DESIGN EXCELLENCE NOTE

Canada Bay Council

Project: 444, 446 Concord Road, 33-41 Blaxland Road, 1-5 Llewellyn Street, Rhodes
Drawings reviewed per attachment.

Date: 10/06/2024

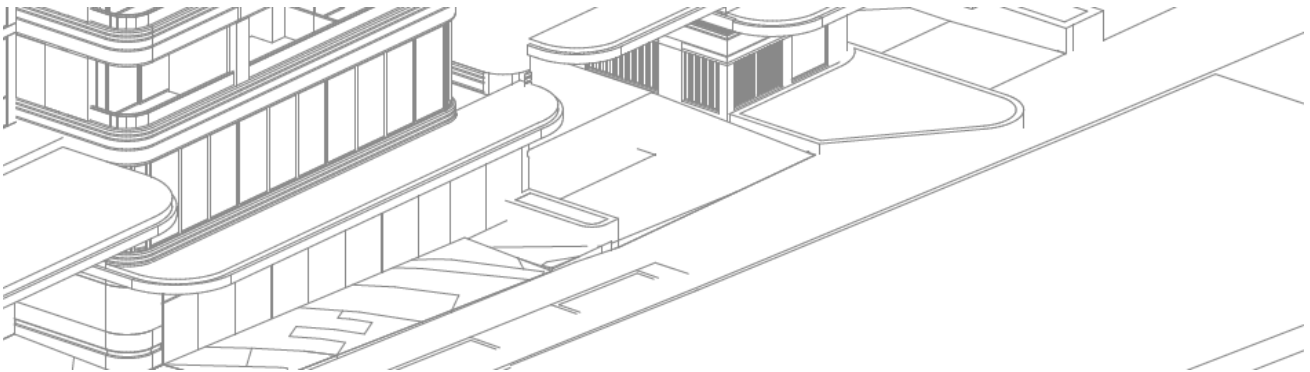
The Blaxland Road frontage near the car park entry projects into the public domain impeding pedestrian movement. The pedestrian footpath should be clear and unobstructed.

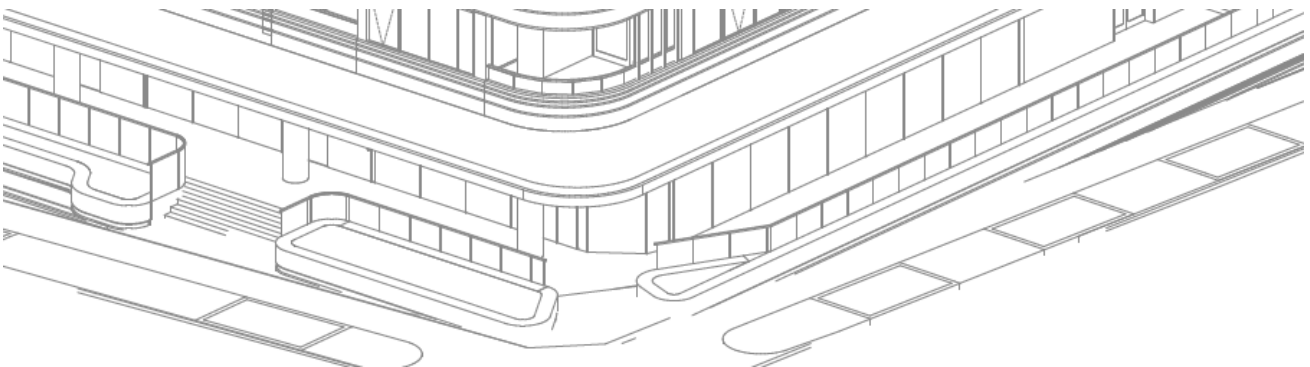
The glass fence is not beautiful and appears unnecessary where it is adjacent to planter boxes. The glass fence should be removed where possible.
